Detailed Site Plan Project Turtle

DSP-23009

STAFF REPORT

SUBJECT: Detailed Site Plan DSP-23009
Project Turtle

Figure 1: Site Plan

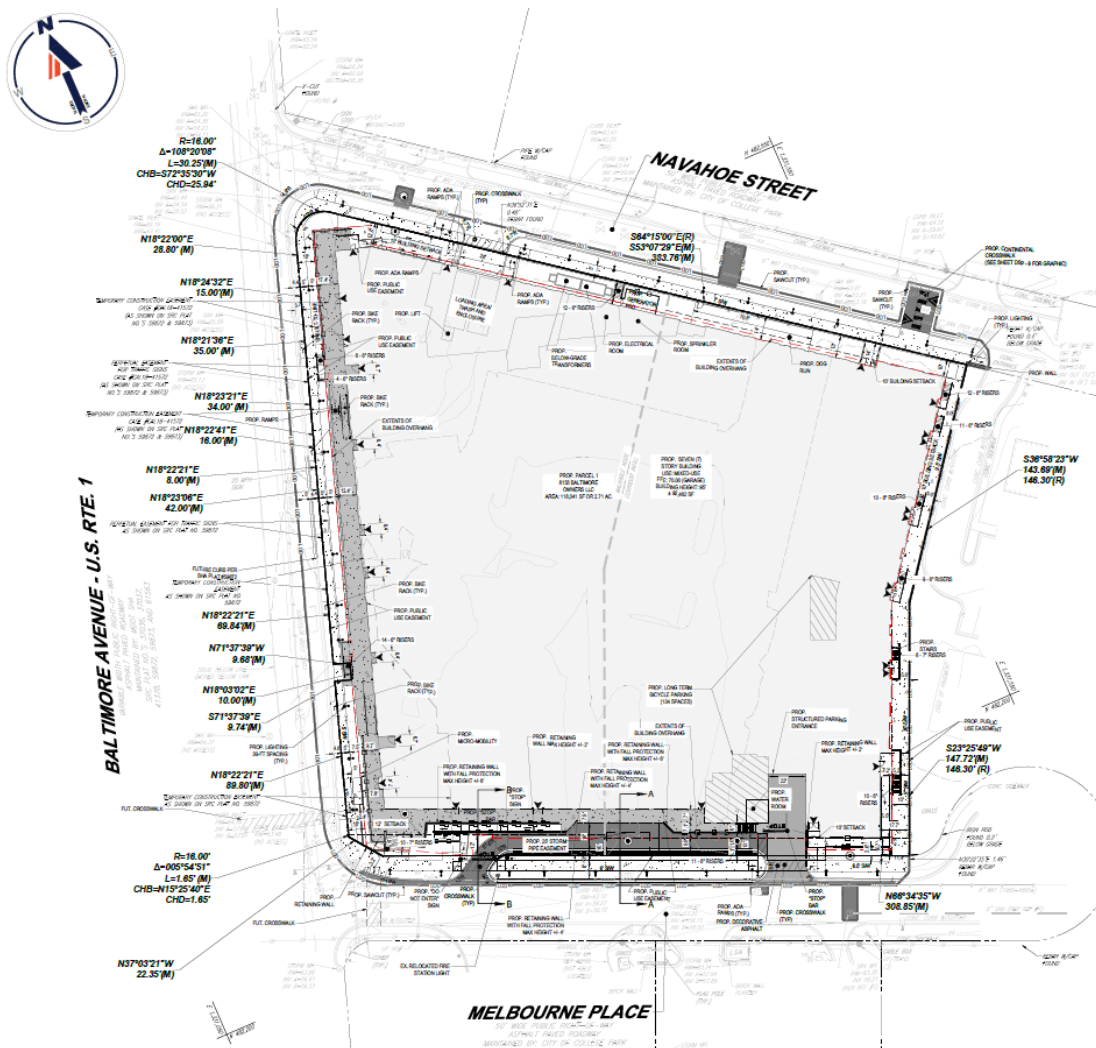
Improved sidewalks are shown along all street frontages of the site. Crosswalks are shown, crossing the drive aisle at two vehicle access points. One is located on Melbourne Place accessing the two-level parking structure, and one is located on Navahoe Street accessing the loading and service area. An elevated crosswalk is also included, across Navahoe Street, at the eastern bounds of the subject site. These improvements connect gaps in the sidewalk network to not only enhance pedestrian connectivity, but to also bring attention to motorists that pedestrians may be crossing.

One vehicle entrance, to the concealed two-level structured parking garage, is located off of Melbourne Place. Inside the parking garage, there is a controlled-access gate to separate the parking spaces for retail and residential uses. Spaces used by commercial retail tenants and their customers are located on level one. Among the parking spaces provided, nine spaces are to be paired with electric charging stations for electric vehicles (EV). A condition is included herein requiring the applicant to provide at least two EV parking spaces for retail use. The layout of the parking garage has been provided and shows the dimensions of parking spaces, with 22-foot drive aisles. This development also provides both long- and short-term bicycle parking spaces, which is discussed above in Finding 2. Two shared loading spaces are located internally, on the north side of the building, accessible from Navahoe Street, and the door to the loading spaces will be open only during move-ins/move-outs and trash pick up.

Figure 2: West Elevation along US 1

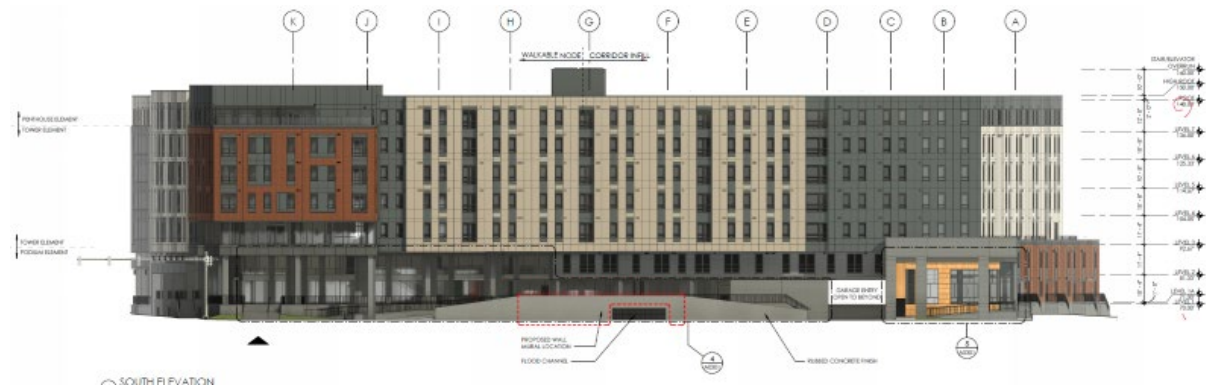
The building façade along US 1 is broken down into three façade types, to mitigate the massing of the building. The slight change in the roof line between the three façade types enables the building to visually appear to be three individual buildings, making it not only visually interesting, but also compatible to the scale of the surrounding neighborhood. The color palette proposed for the building consists of a strong dark masonry, two-story building base, and light and dark grey architectural panels on the upper floors, and dark finished window frames and storefronts. The design of a strong base-middle-top expression is also included across the elevations of the building. The intersection of US 1 and Melbourne Place has a strong red brick massing that emphasizes this corner of the building. On the north elevation, the applicant noted the location of the proposed wall mural, without any details included in the submission. A condition is included herein requiring the applicant to provide such details.
